FRAME REINFORCEMENT AND TAIL LAMP WIRING / XL, XLCH

All 1973 XL and XLCH motorcycle frames will require corrective modification as specified in this bulletin to prevent possible breakage at the welded junction of the frame tubes and the rear fender and shock absorber support bracket. Some cases of breakage have been reported from the field and is caused by heavy stress concentration in this location.

In compliance with the National Motor Vehicle Safety Act, this has been declared a safety defect and all affected vehicles will require welded reinforcing braces installed according to the instructions given in this bulletin.

FIGURE 1

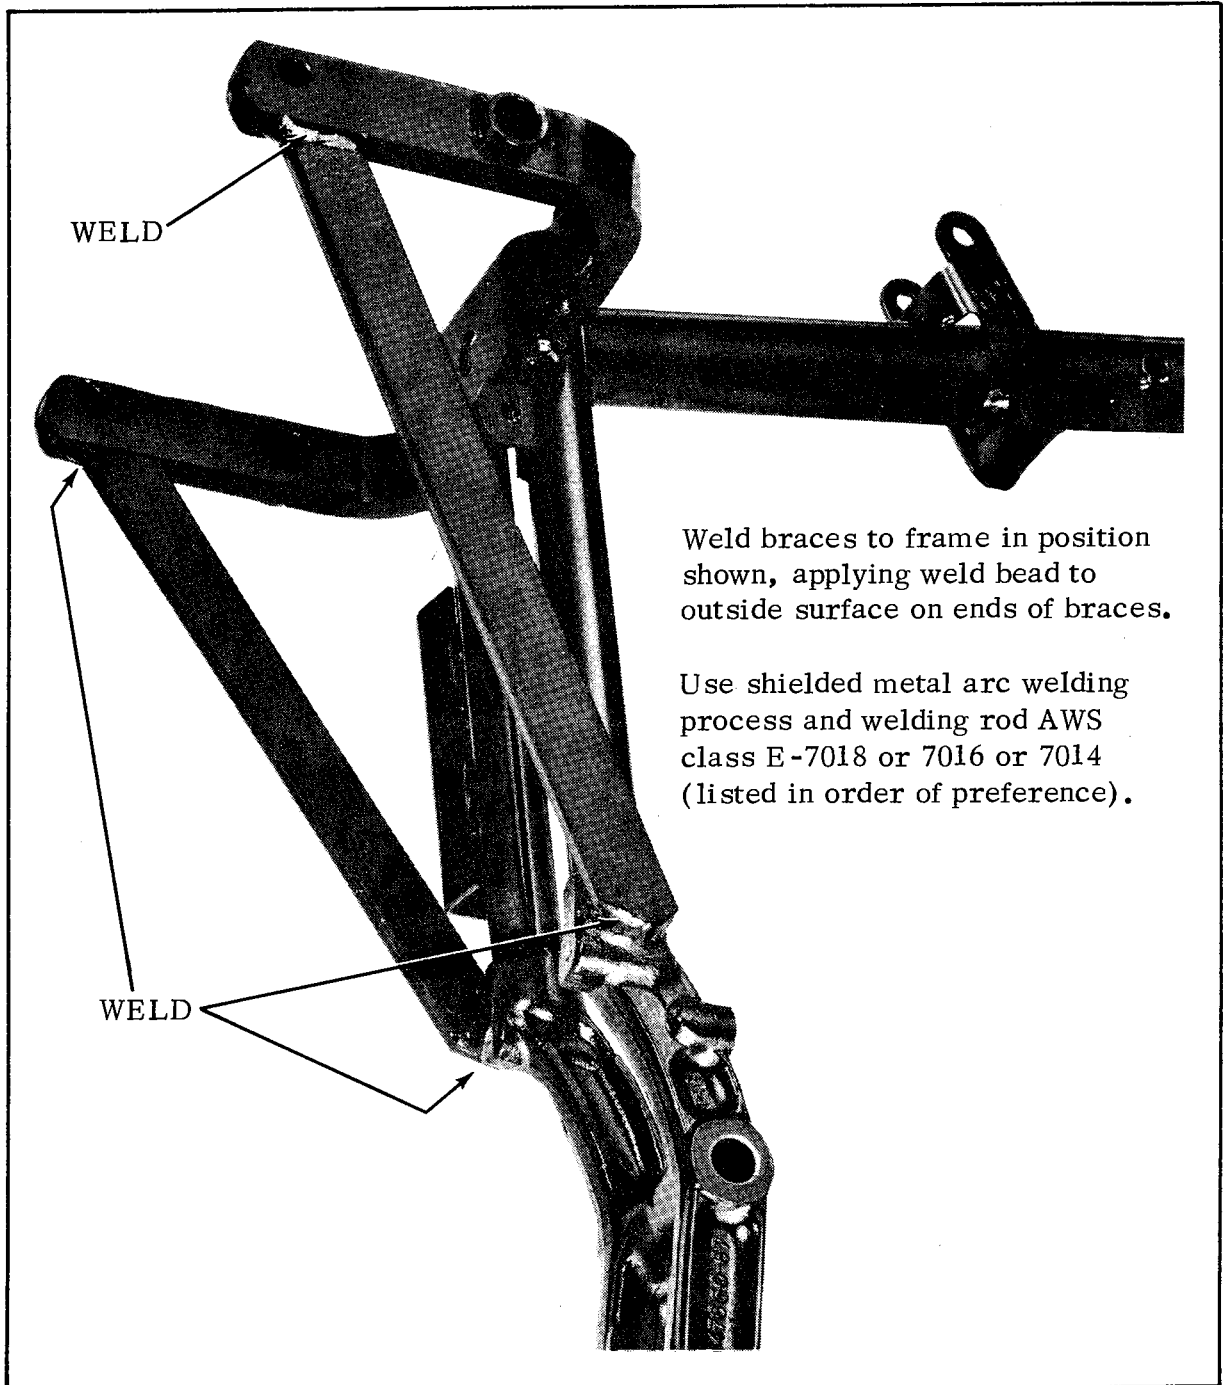
Arc weld braces (item 1) in place as shown in Figure 1 using shielded metal arc welding process. The areas to be welded MUST be free of paint, oil and dirt. Only the following 1/8 or 3/32 AWS electrodes, listed in order of preference, should be used.

With each brace held in position, tack weld at upper end first--then weld lower end completely. Be sure to protect fender paint while welding.

AWS Class E-7018, E-7016 or E-7014

Braces should be held tightly in place and parts at room temperature for welding.

Power source can be DCRP (Direct Current Reverse Polarity - electrode positive) or AC (Alternating Current); DCRP is preferred. In general, good welding practice should be followed.

FIGURE 2

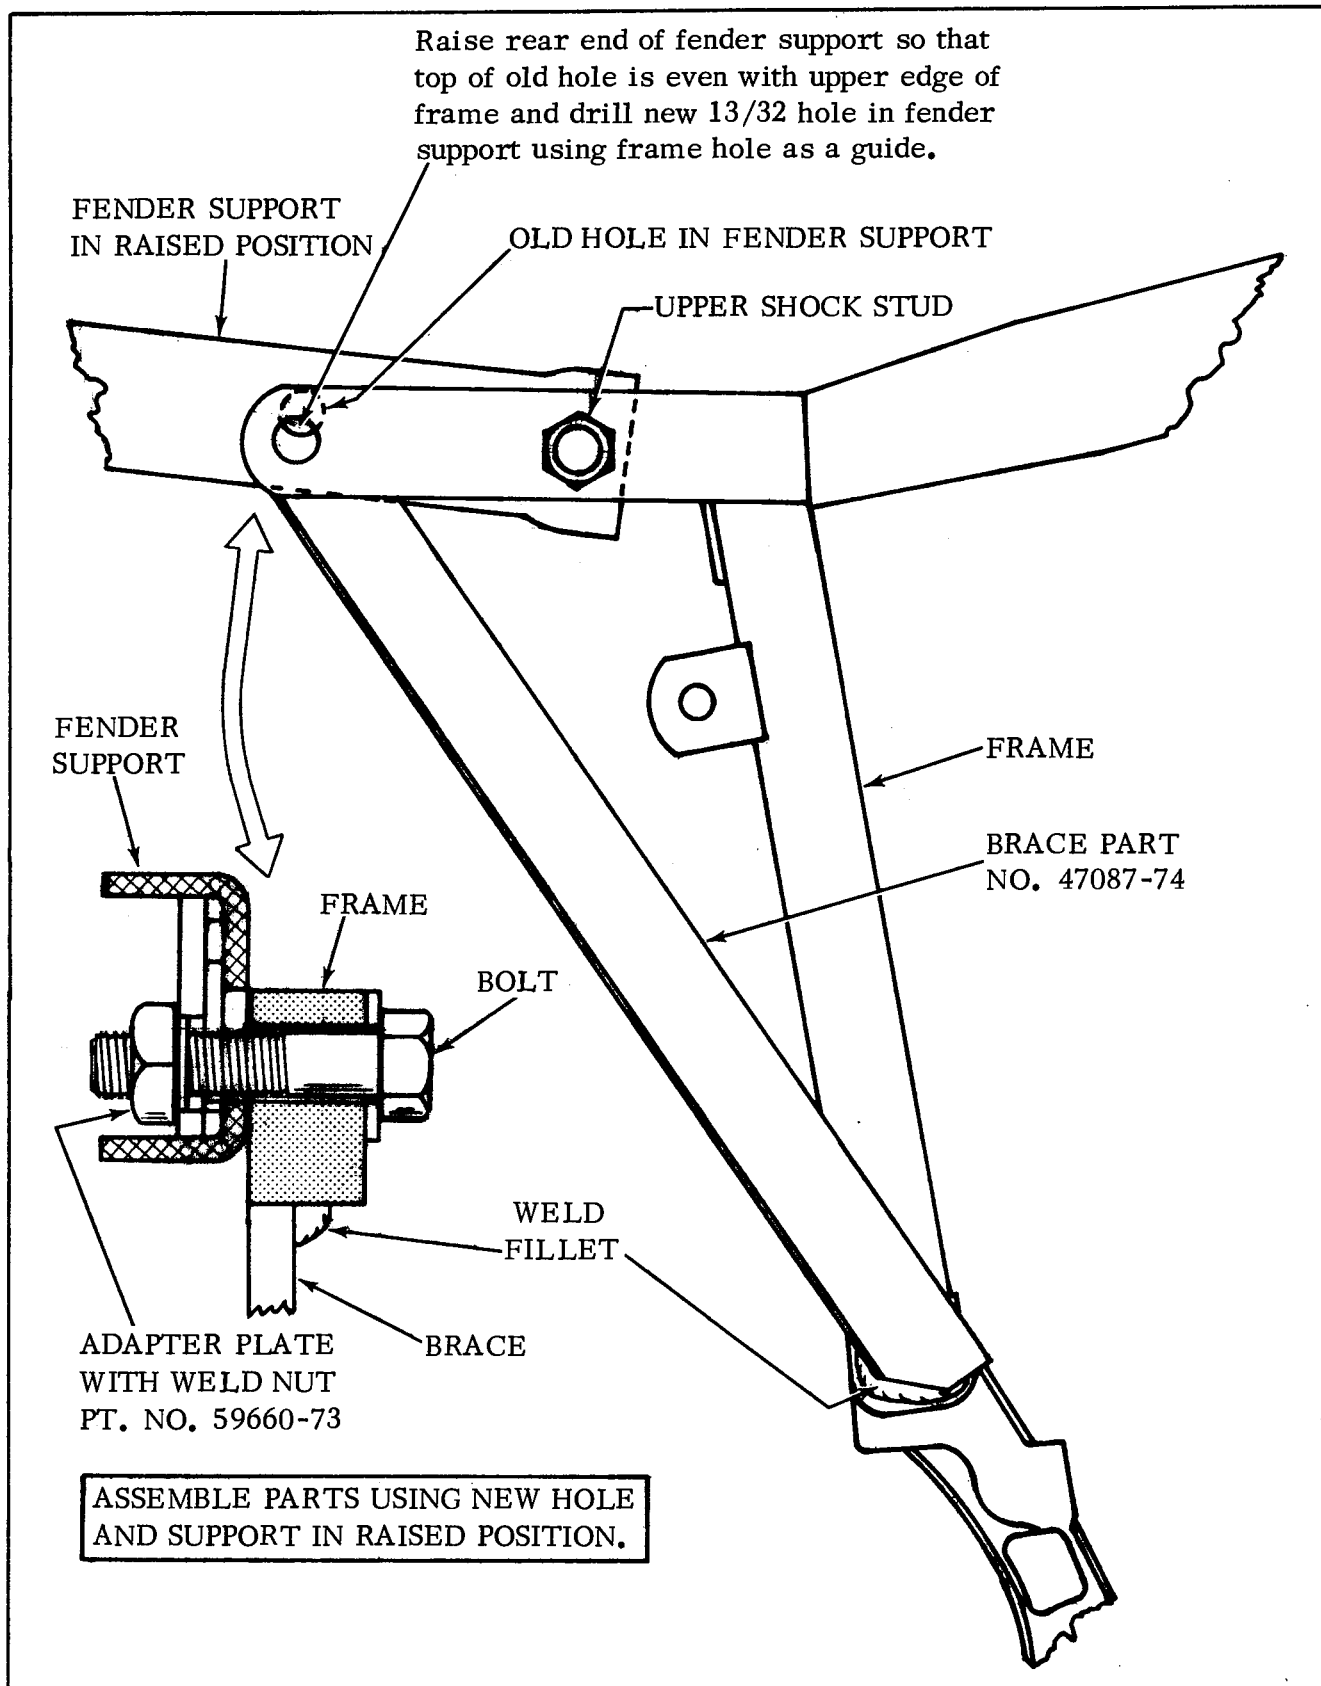
6. The mounting hole in the fender support is to be drilled 1/4 inch lower. Lowering the position of this hole will have the effect of raising the rear end of the fender 1-1/2 inches, providing more clearance between the rear wheel and fender.

To drill the new hole in the fender support, rotate fender supports upward until tip of existing hole lines up with top of frame (see Figure 2). Drill out brace with 13/32 drill on each side being careful not to damage wiring on left side.

7. While fender is in raised position and before reinstalling bolts, apply adhesive to fender pad from kit and install over old pad.
8. Lower fender and install fender adapter plates on inside of braces as shown in Figure 2. Note that weld nut is off center and should be located in lowest position to line up with bolts. Reinstall bolts with washers in new location.

Note: Brace upper end should be positioned with inside surface flush with inside surface of frame bracket as shown in Figure 2 so that weld will form a fillet with good penetration.
